# Access Compliance Report

## Public Rights-of-Way

### (Curb Ramps)

Intersection ID: 48493	Main Street: NEWTONMORE_DR	Cross Street: BEREWICK_COMMONS_PY	Location: SE
ADA ID: EAFE030662A7	Ramp Type: PerpDiag	Initial Pass/Fail: Fail	Overall Compliance: No
Severity Score: 8.75			
Codes/Mitigation Info/Possible Solution		Field Measurements/Component Compliance

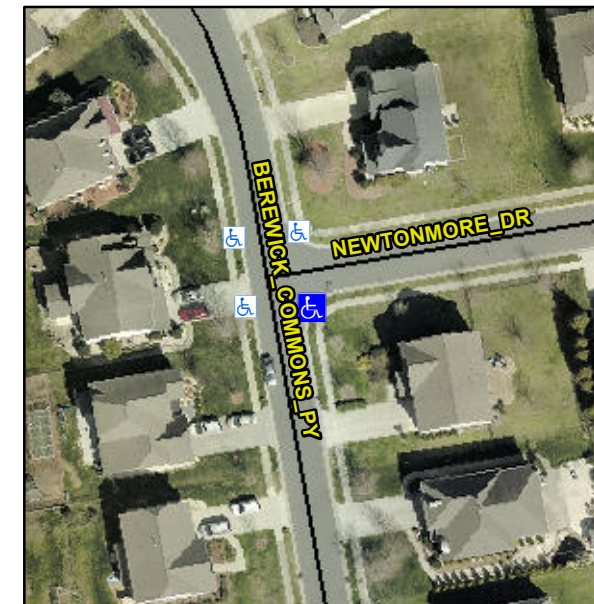
**Not Found, R304.5.1**

Compliance	Description	Data	Compliance	Description	Data
N/A	Ramp Length (in)	48.0	Yes	Ramp Slope (%)	6.5
No	Ramp Width (in)	44.0	Yes	Ramp XSlope (%)	0.5
N/A	Flare Type LT	N/A	N/A	Flare Type RT	N/A
N/A	Flare Slope LT (%)	N/A	N/A	Flare Slope RT (%)	N/A
N/A	Flare Traversable LT?	N/A	N/A	Flare Traversable RT?	N/A
N/A	Landing Length (in)	N/A	N/A	DWS Provided?	N/A
N/A	Landing Width (in)	N/A	N/A	DWS Contrast?	N/A
N/A	Landing Slope (%)	N/A	N/A	DWS Length (in)	N/A
N/A	Landing X Slope (%)	N/A	N/A	DWS Full Width?	N/A
N/A	Landing Curb? (Y/N)	N/A	N/A	DWS Offset (in)	N/A
N/A	Shared Landing?	N/A			
N/A	Gutter Ponding?	N/A	N/A	Gutter Slope (%)	N/A
N/A	Gutter Lip Ht (in)	N/A	N/A	Gutter X Slope (%)	N/A
N/A	Painted X Walk1?	No	N/A	Painted X Walk2?	No
	X Walk 1 Direction	To N		X Walk 2 Direction	To W
N/A	X Walk 1 Width (in)	N/A	N/A	X Walk 2 Width (in)	N/A
	X Walk 1 Slope (%)	3.5		X Walk 2 Slope (%)	2.6
	X Walk 1 X Slope (%)	0.1		X Walk 2 X Slope (%)	3.6

**Remove & Replace Curb Ramp With Two New Directional Ramps or Equivalent.**
